**RE: BEK Distribution Facility
601 Gallatin Place NW
Grading and Drainage Plan & Drainage Report
Engineer's Stamp Date: 09/06/19
Hydrology File: J10D002G1**

Based upon the information provided in your resubmittal received 09/06/2019, the Grading & Drainage Plan and Drainage Report are approved for Building Permit, Grading Permit, and for action by the DRB on Site Plan for Building Permit.

RE: **BEK DISTRIBUTION FACILITY – 601 GALLATIN PL. NW
D&D PLAN AND DRAINAGE REPORT ENGINEERS
STAMP DATE 07/19/2019, HYDROLOGY FILE: FJ10D002G1**

Revision No.	△
Job No.	2018014
CAD/CHK'D By.	pm / vc
Date	8-16-19
Sheet Title	ROOF DRAIN PLAN AND PROFILE
Sheet No.	C210
	CIVIL

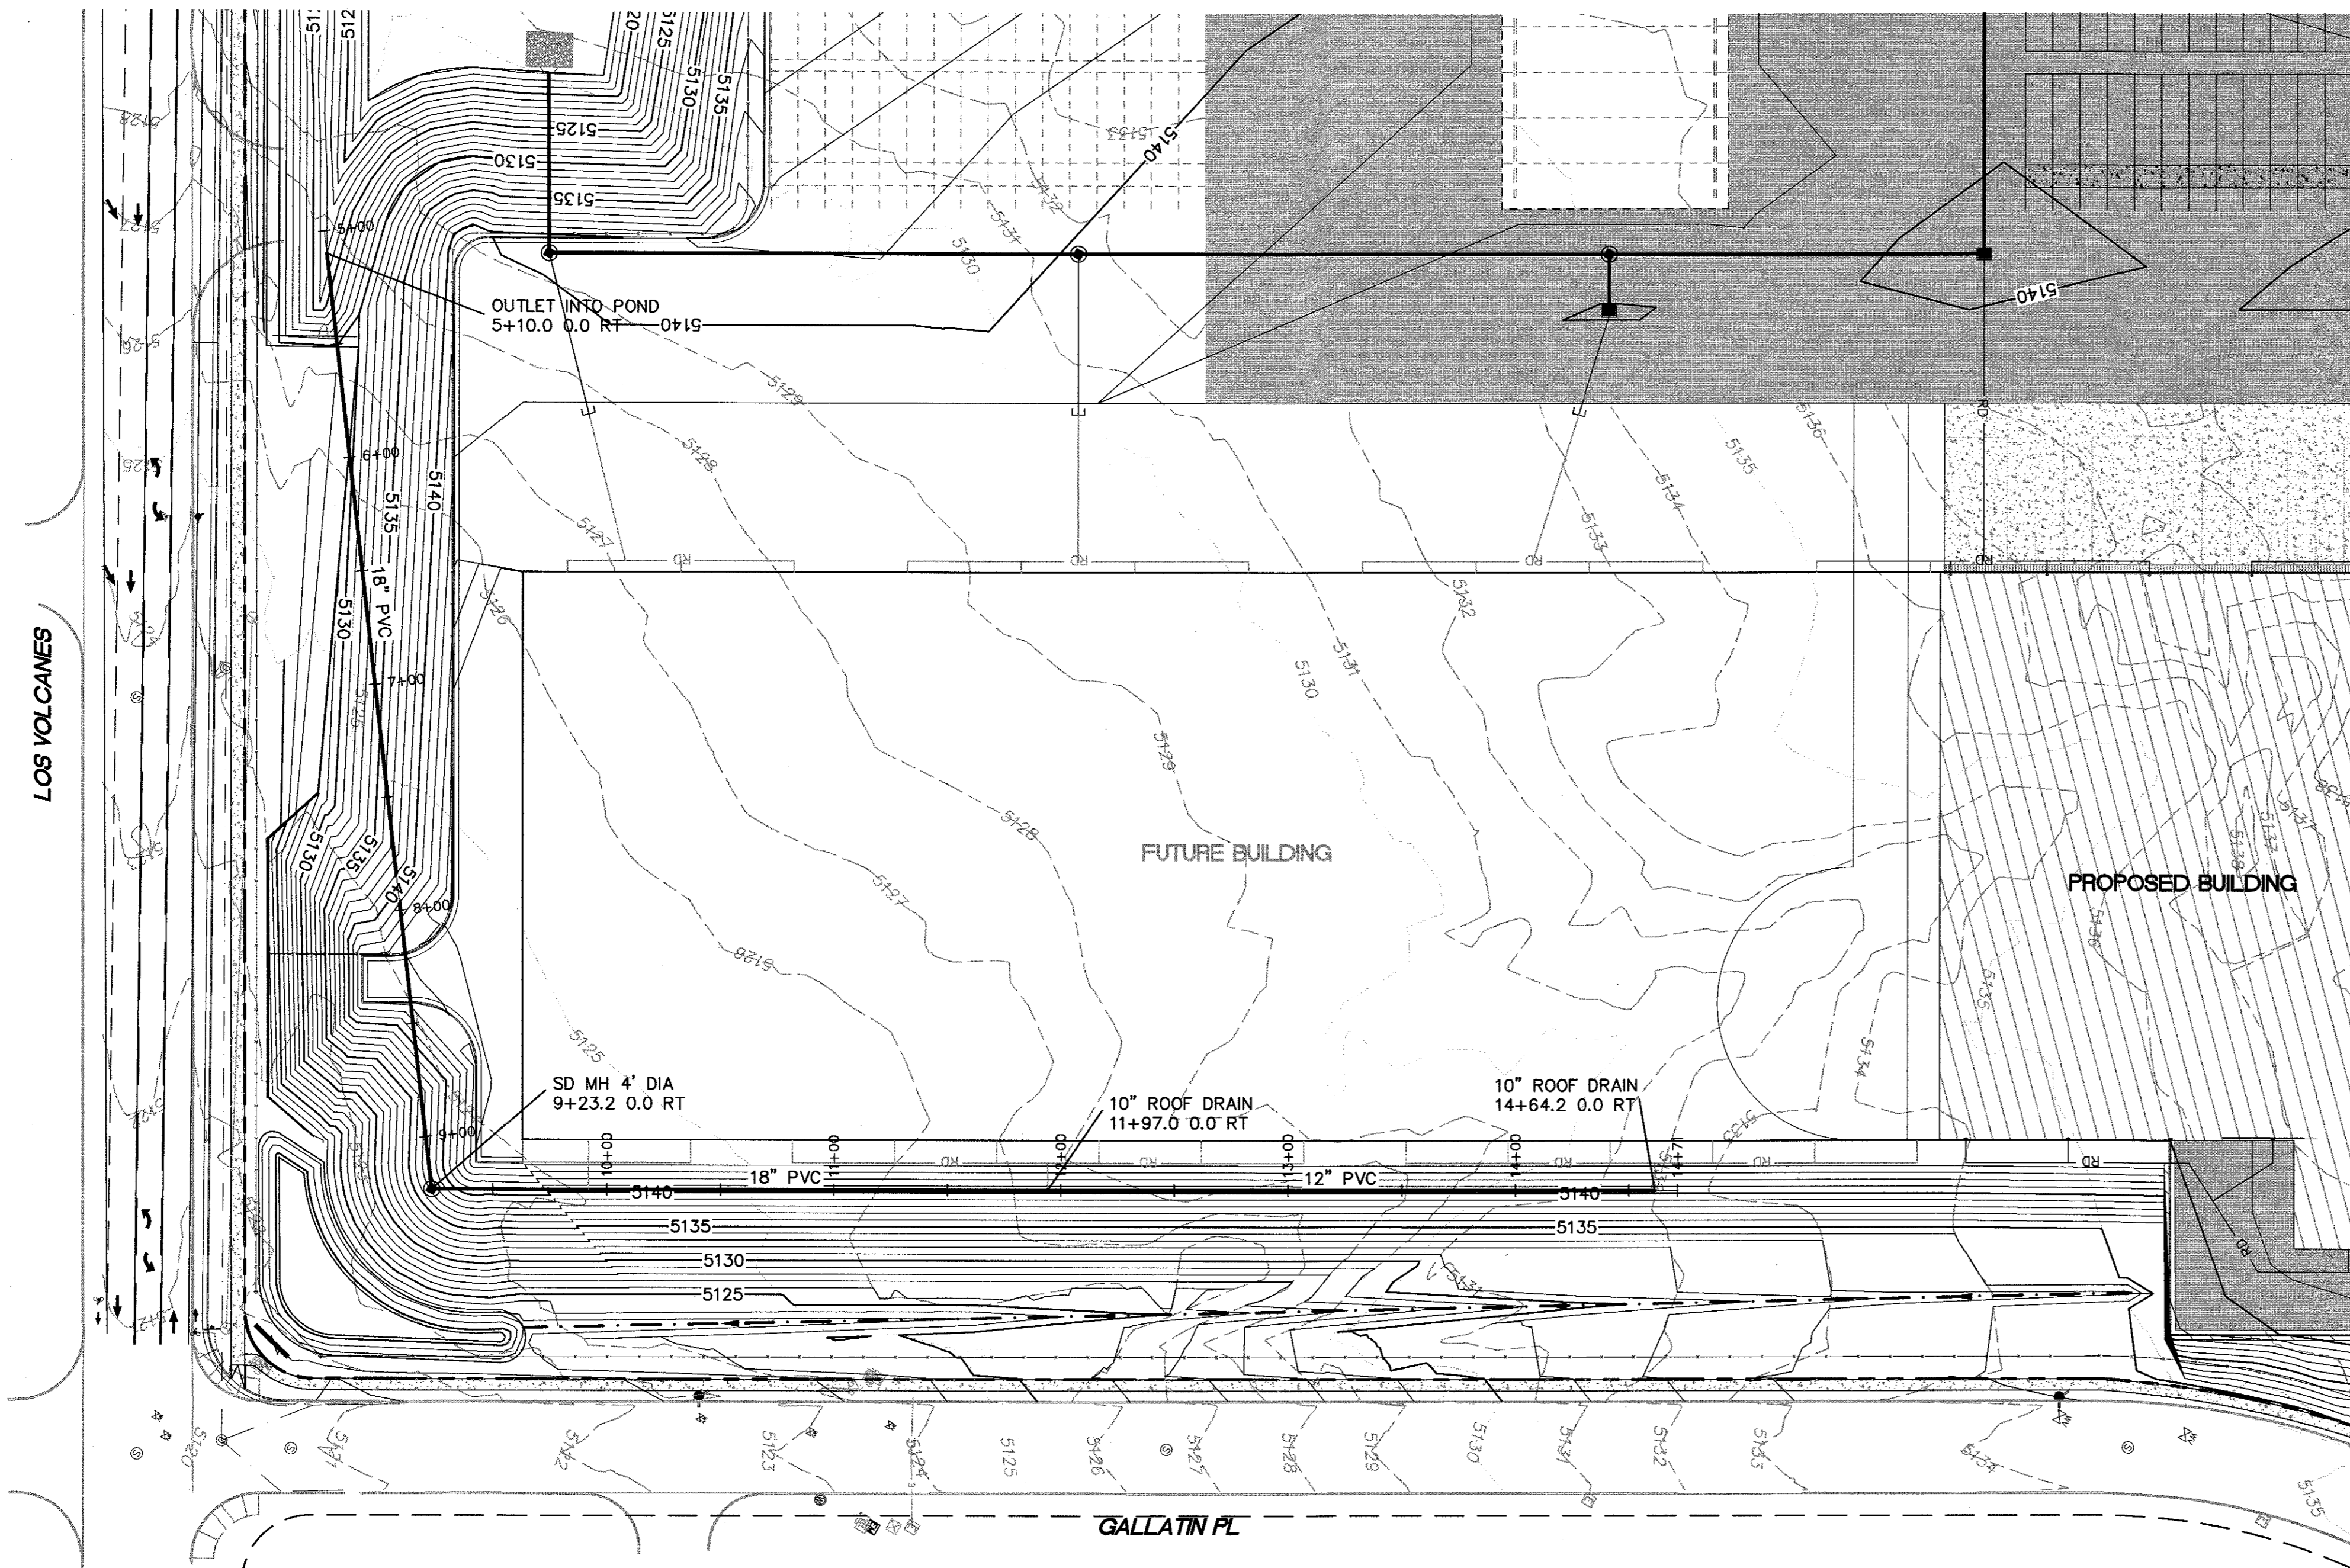
Response: The finish contours were added in the noted area on Sheet C203. Typical sections of this area are shown on Sheet C213, Section G.
11. HGL calculations are required for the storm drain in the north east corner of the site where failure of the storm drain could result in excessive storm water runoff to public streets. Also please add a profile and HGL calculations for the storm drain on the south and east side of the building.

Response: HGL profile and calculations were added to the plan Sheets C206, C210 & C211 and report for the storm drains in the northeast corner of the site and the southeast side of the building.
